ATTACHMENT C:

ASSESSMENT: DEVELOPMENT CONTROL PLAN - MULTI DWELLING HOUSING

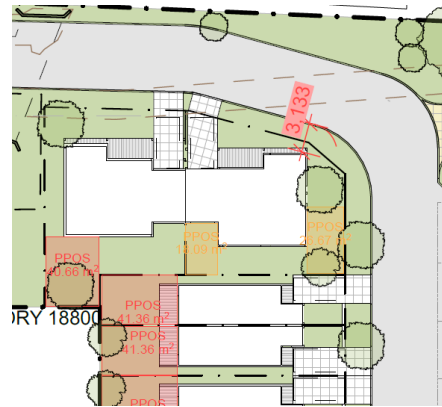
3. **Site coverage and Private open space –**

The following dwellings have non-compliance with one of the standards relating to “site coverage and private open space”.

1. Unit 46 does not meet minimum POS requirements of 40sqm with a minimum dimension of 5m.

The following suitable justification has been provided for this variation:

Dwelling 46 does not wholly comply with dimension and area requirements. This is largely a result of required access road and ultimately dwelling location. Notwithstanding this, the particular dwelling benefits from greater outdoor space which benefits from extended solar access. Whilst the two locations of POS on the proposed plans, it could be considered the areas immediately adjoining the Kitchen Dining area are suitable also to be considered as POS. The POS identified which also is identified on the “roadside of the dwelling” benefits from screening and landscaping that the whole yard will benefit from. This 2-bedroom dwelling benefits from approximately 145sqm of outdoor space.

The extensive outdoor areas, location of this outdoor area and the reasons identified above result in an outcome that is considered appropriate, despite not complying entirely with the prescribed guidelines.
